Subject: Quad Cities Station Units 1 and 2  
Core Shroud Repair Hardware Inadvertent Loading  
NRC Docket Nos. 50-254 and 50-265

Revised 10 CFR 50.59 Safety Evaluation - Core Shroud Repair  
Revision 4, June 16, 1995

## 10CFR50.59 SAFETY EVALUATION, REVISION 4

FIGURE 1. HORIZONTAL WELD LOCATIONS

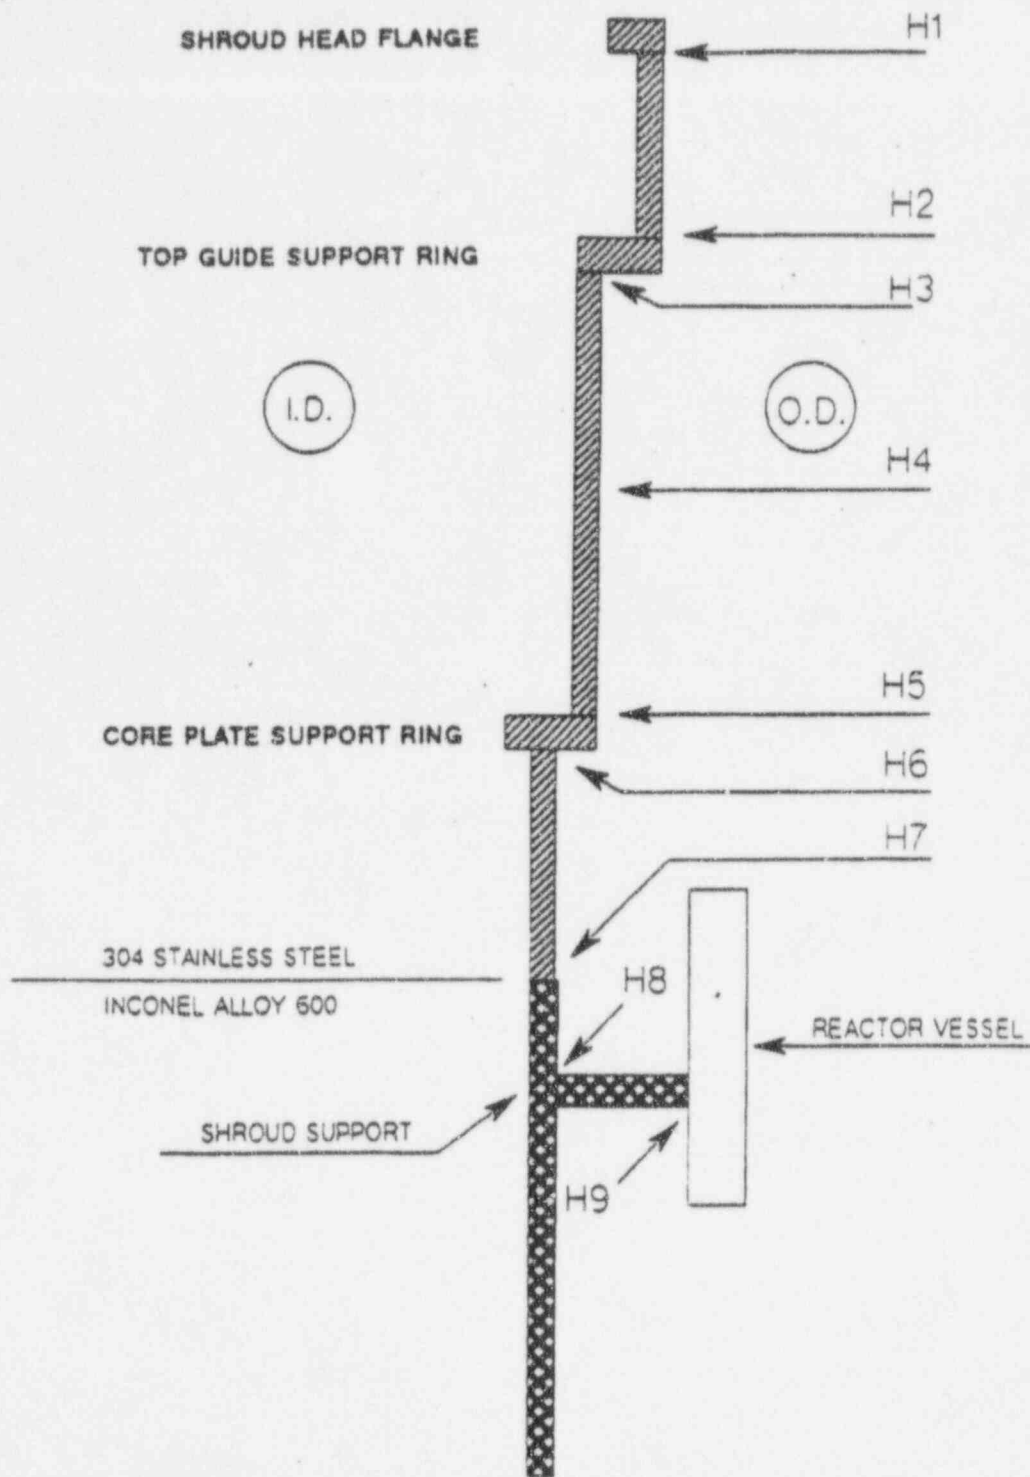
## BACKGROUND INFORMATION (see figure 1):

In 1990, crack indication were reported at core shroud welds located in the beltline region of an overseas reactor (BWR-4). This reactor had completed approximately 190 months of power operation before the cracks were discovered. As a result of this discovery, GE Nuclear Energy (GENE) issued Rapid Information Communication Services Information letter (RICSIL) 054, "Core Support Shroud Crack Indications," on October 3, 1990, to all owners of GE BWRs. This RICSIL summarized cracking found in the overseas reactor and recommended that at the next refueling outage, plants with high carbon type 304 stainless steel shrouds perform a visual examination of the accessible areas of the seam welds and associated heat affected zone, on the inside and outside surfaces of the shroud.

FIGURE 2. SHROUD STABILIZER

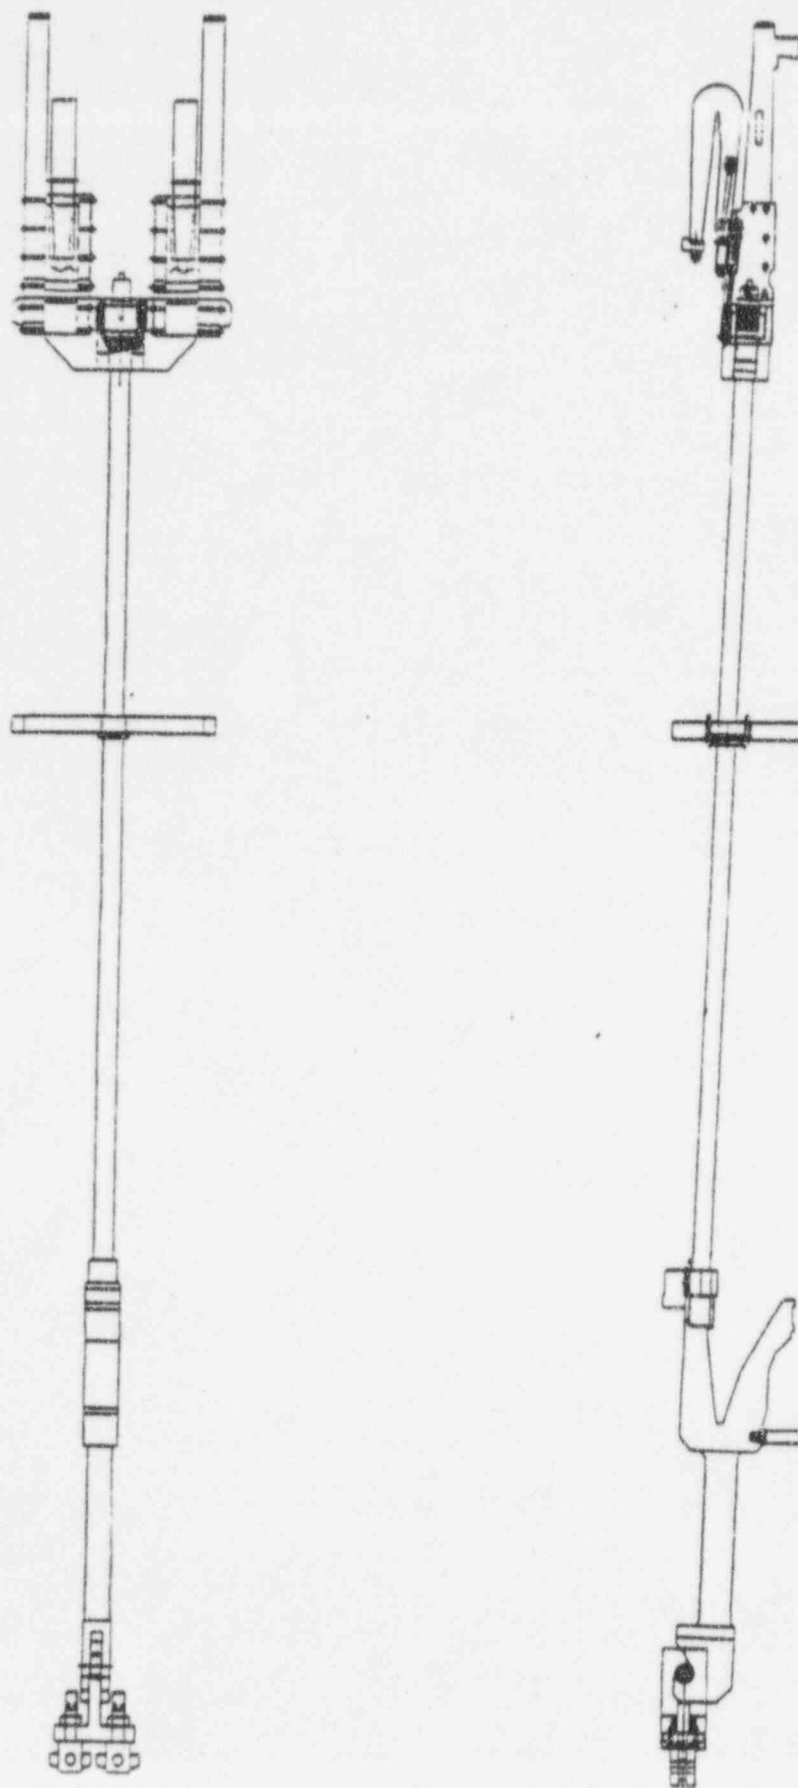
#### SHROUD PROBLEM SOLUTION (see figure 2):

The technical design requirement is that the repair design structurally replaces the core shroud horizontal welds H1 through H7 if these welds fail completely through wall. In addition, for design purposes the circumferential jet pump support plate H8 weld is to be considered cracked completely through and 360 degrees. Also, the design should not result in a driving mechanism for Intergranular Stress corrosion Cracking (IGSCC) in these welds or any other component in the reactor vessel such that it reduces the operating margin available from the remaining ligaments of the welds.

The core shroud repair is designed to structurally replace the core shroud's horizontal welds H1 through H7 and provide vertical clamping forces on the shroud in the event that any or all the seven shroud horizontal weld joints are cracked through wall. In general the core shroud repair design installs low tension tie rods with spring stabilizers connected between the separator head support ring and the jet pump support plate. Four tie rods will be evenly distributed in the annulus region of the reactor pressure vessel. Spring stabilizers will be mounted at the top guide support ring (welds H2/H3) and the core plate support ring (welds H5/H6) in the annulus area between the core shroud and the reactor pressure vessel wall. A middle spring stabilizer is mounted on the tie rod at the same elevation as the jet pump riser braces.
